# Access Compliance Report

## Public Rights-of-Way

### (Curb Ramps)

Intersection ID: 20684	Main Street: PARK_SOUTH_DR	Cross Street: STOKES_AV	Location: SE
ADA ID: 45CC34311E6B	Ramp Type: BlendTrans2	Initial Pass/Fail: Fail	Overall Compliance: No
Severity Score: 8.75			
Codes/Mitigation Info/Possible Solution		Field Measurements/Component Compliance

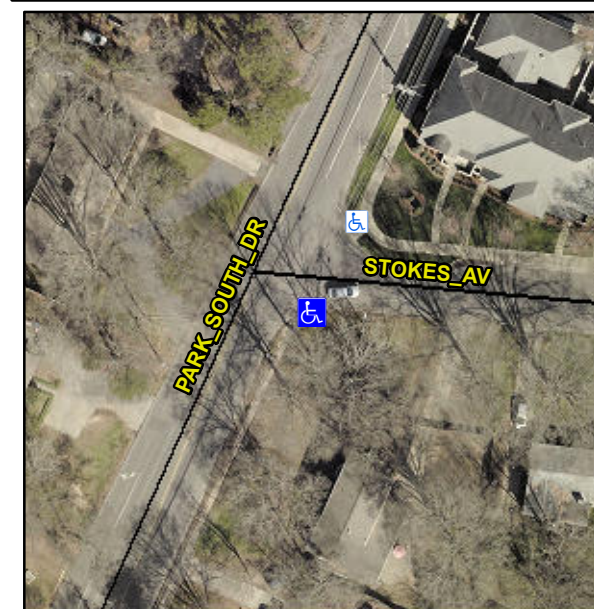
**Not Found, R304.5.1**

Compliance	Description	Data	Compliance	Description	Data
N/A	Ramp Length (in)	64.0	Yes	BlendTrans Slope (%)	3.0
No	Ramp Width (in)	47.0	Yes	BlendTrans XSlope (%)	1.6
N/A	Flare Type LT	N/A	N/A	Flare Type RT	N/A
N/A	Flare Slope LT (%)	N/A	N/A	Flare Slope RT (%)	N/A
N/A	Flare Traversable LT?	N/A	N/A	Flare Traversable RT?	N/A
N/A	Landing Length (in)	N/A	N/A	DWS Provided?	N/A
N/A	Landing Width (in)	N/A	N/A	DWS Contrast?	N/A
N/A	Landing Slope (%)	N/A	N/A	DWS Length (in)	N/A
N/A	Landing X Slope (%)	N/A	N/A	DWS Full Width?	N/A
N/A	Landing Curb? (Y/N)	N/A	N/A	DWS Offset (in)	N/A
N/A	Shared Landing?	N/A			
N/A	Gutter Ponding?	N/A	N/A	Gutter Slope (%)	N/A
N/A	Gutter Lip Ht (in)	N/A	N/A	Gutter X Slope (%)	N/A
N/A	Painted X Walk1?	No	N/A	Painted X Walk2?	No
	X Walk 1 Direction	To NE		X Walk 2 Direction	To W
	X Walk 1 Width (in)	N/A		X Walk 2 Width (in)	N/A
	X Walk 1 Slope (%)	3.6		X Walk 2 Slope (%)	3.5
	X Walk 1 X Slope (%)	2.1		X Walk 2 X Slope (%)	2.6

N/A	Ramp inside XWalk1?	N/A	N/A	Ramp inside XWalk2?	N/A
	Road Slope (%)	1.6		Clear Space?	N/A
	Road X Slope (%)	3.7	N/A	Clear Space to XWalk (in)	N/A
N/A	Any Obstructions?	N/A	N/A	Storm Grate/Utility Hazard?	N/A
	Obstruction Type			Storm Grate/Utility Type	
		N/A			N/A
			Yes	Surface Condition? (G/P)	Good
			No	Curb Slope (%)	13.6

**Remove & Replace Curb Ramp With Two New Directional Ramps or Equivalent.**
